To: City of Santa Clara Planning Commission
Project: 2892 Mesquite Dr, File Number 25-1682, PLN25-00295

Subject: Appeal of Conditional Approval – Request to Clarify and Make Enforceable Conditions P3 and P4

Exhibit A: Projected sight line diagrams submitted with our previous public comments (2025)

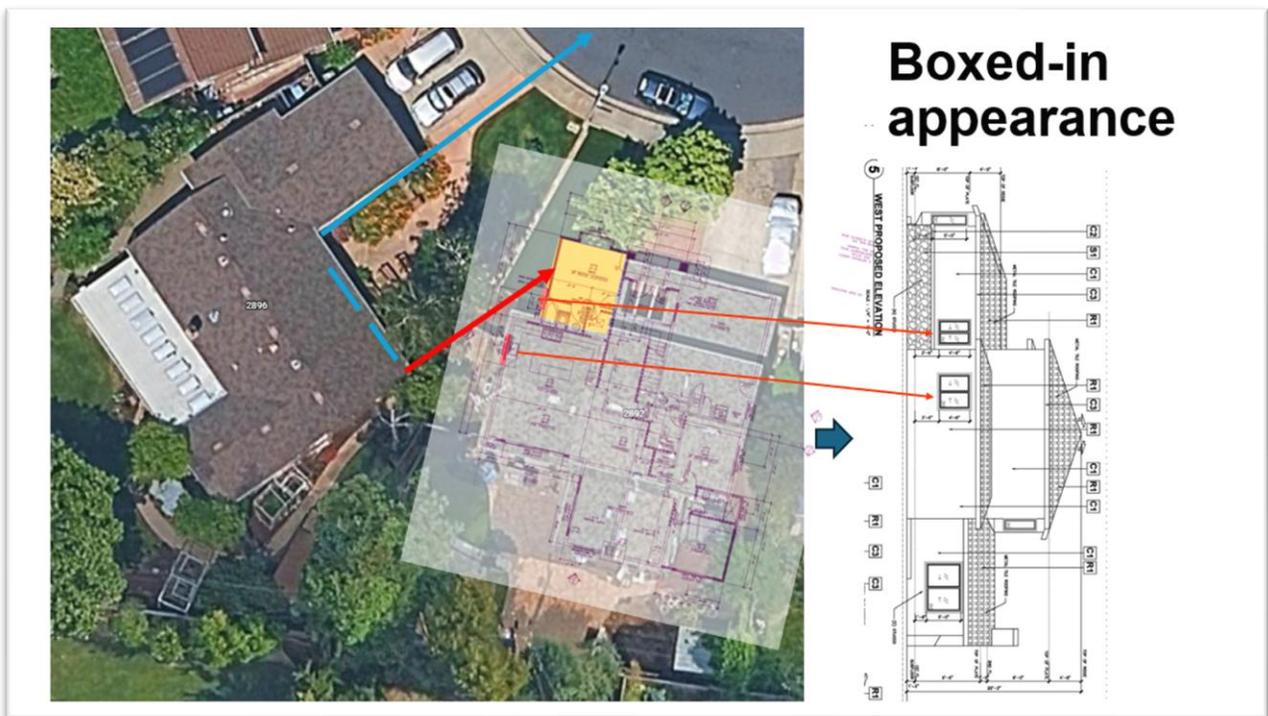
Conditions P3 and P4 were presented as the key mitigation mechanisms for the very impacts we raised (sight line/openness and privacy/visibility).

1) Condition P3 is vague and lacks a measurable compliance standard

P3 requires the guest bedroom to "adhere to the prevailing development pattern... by reducing the footprint... providing a greater front and side setback... [and] preserve the existing sight line."

Sight line Photos with current structure.

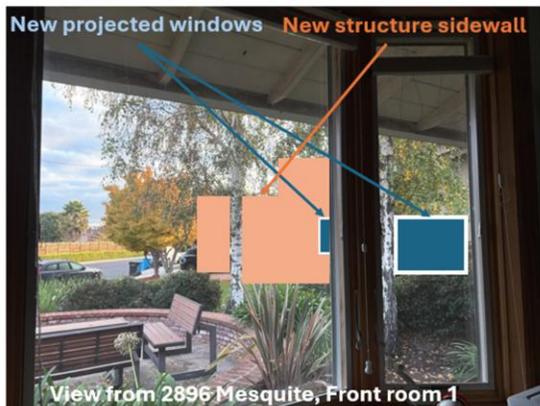
New plan proposed construction (1/8/2026)

Negligible change from the previous P3/P4 non-compliant proposal.
Sight line is as impacted as in the old plan.

**Boxed-in appearance.
Photos with new extension simple rendering**

This new appearance would diminish the enjoyment of our home and lower its value and desirability.

New plan with additional tall fence 1/8/2026

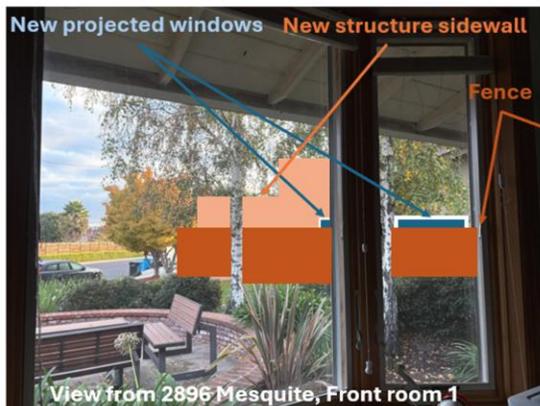
New proposed fence in front of the current fence line **impacts even more** the sight line.
The new plan raises a tall fence literally in front of our home!

**Boxed-in appearance.
Photos with new extension and new fence
simple rendering**

This new appearance would further diminish the enjoyment of our home and lower its value and desirability.

Preserve Front Yard Sight Lines

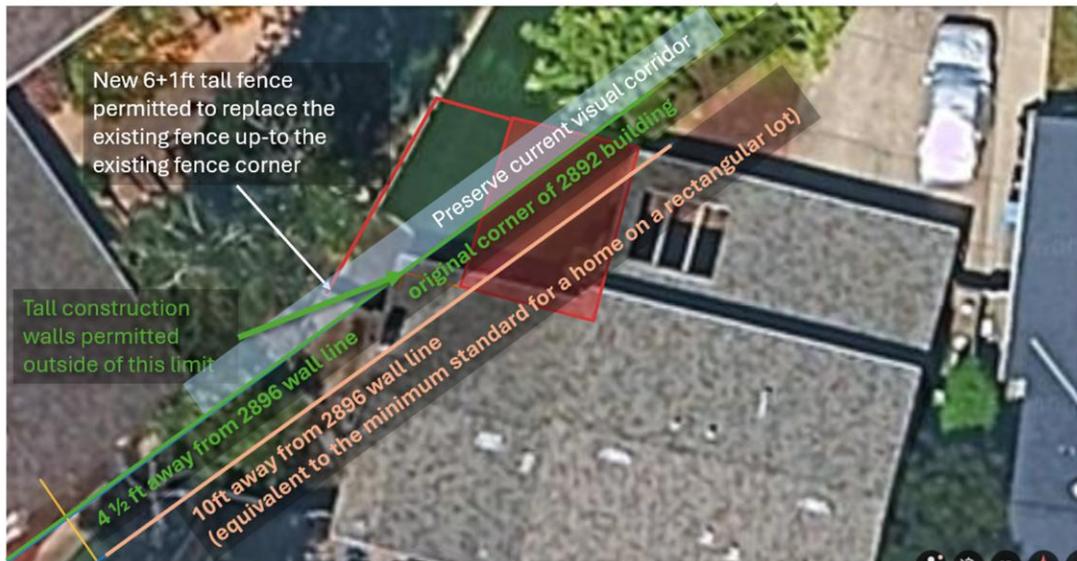
Without objective limits (height/opacity/location), these elements can create additional sight line obstruction and negate P3's intent, yet the approval does not clarify how P3 controls if conflicts arise.

The updated plans include a 6+1ft fence, extending far to the front, **22 feet** from the end of the existing fence, that is there since we purchased our home.

This creates even worse blockage of the front of our house and the windows of the main front rooms.
